Subject: Collin County Healthcare Facility, Parking Garage, and Medical Examiners
Revised Request for Change (PCO) No. 030; RFI #111 Cast Stone in Lieu of EIFS at HCB Entrances

Issue No. 030 - RFI #111 Cast Stone in Lieu of EIFS at HCB Entrances

**Option 1: Change EIFS at South, West
& North Elevations to Cast Stone**

COR#02_Collin_County_EIFS to Cast Stone_Rev2_20250328

Current Detail

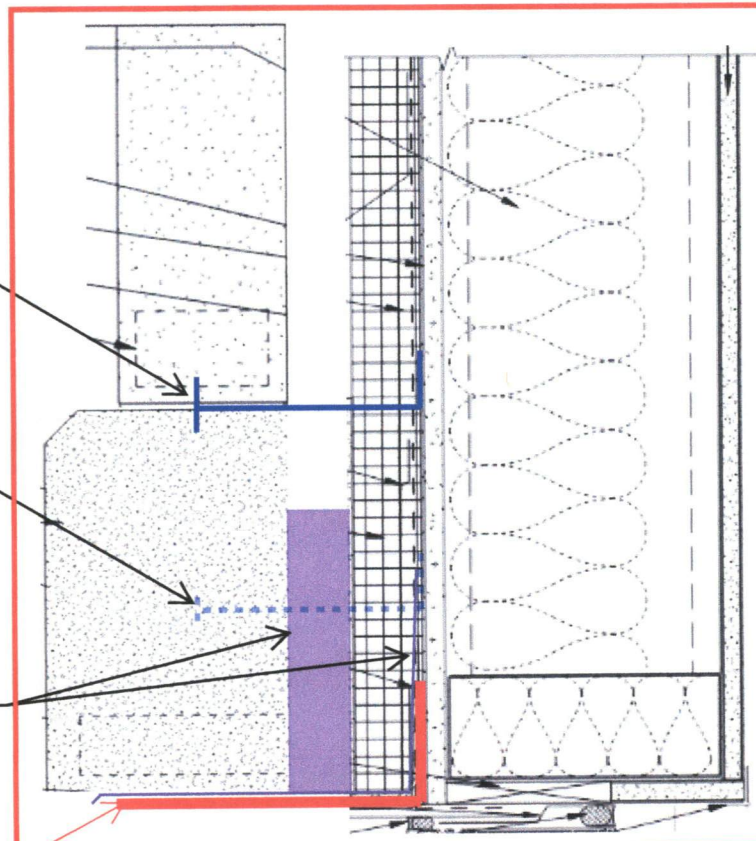
Design change if cast stone is selected to be installed in lieu of EIFS at South, North & West elevations at the storefront.

This lintel & break metal flashing would be removed. The wall cavity accessories would be shifted down to sit on the lintel. See image below.

Proposed change order to include cost credits for labor, materials and equipment, including steel lintel and associated flashing.

Refer to Dtl. 12/ HC A0.35 for typ. flashing details. Use Stainless steel flashing at cast stone accent.

Shop drawings to include minimum requirements for modified design to anchor cast stone on arched steel lintel with securely anchored cast stone accent per cast stone manufacturer's requirements as specified by the Cast Stone Institute design recommendations, SMACNA and Masonry Institute recommendations for a water-tight installation, including separation of materials to prevent stains from efflorescence. Include structural engineering calculations for steel lintel with structural support to wall assembly and structure.

HC-A6.02

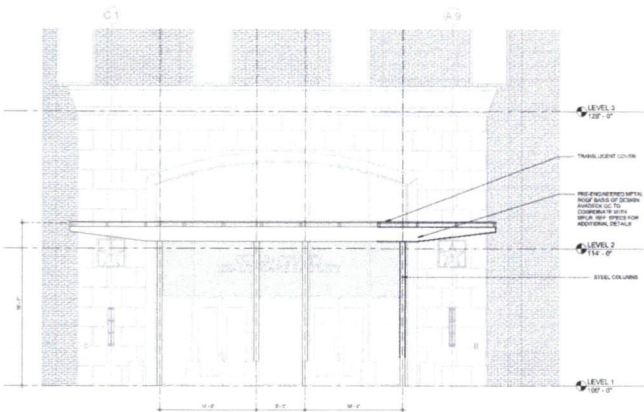
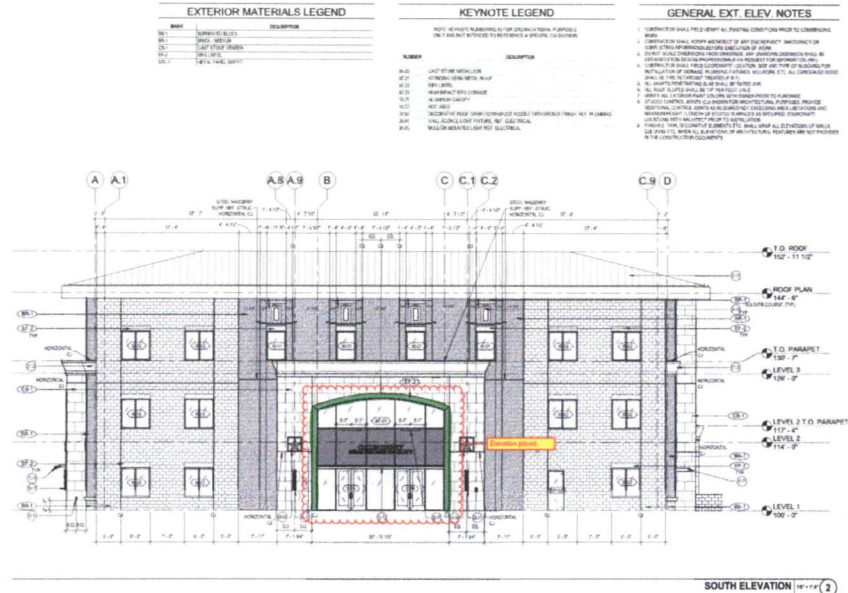
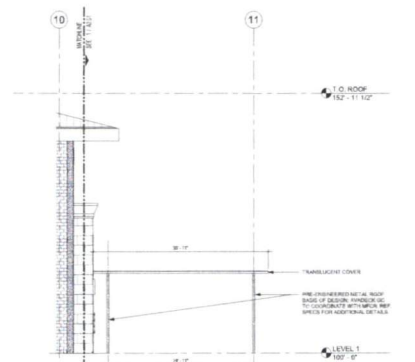
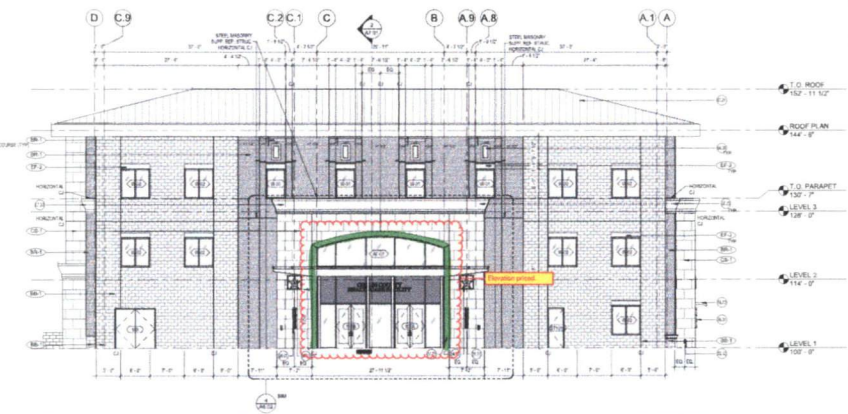
Description of Change: Change South, West, and North elevation curtain wall EIFS lintel to cast stone
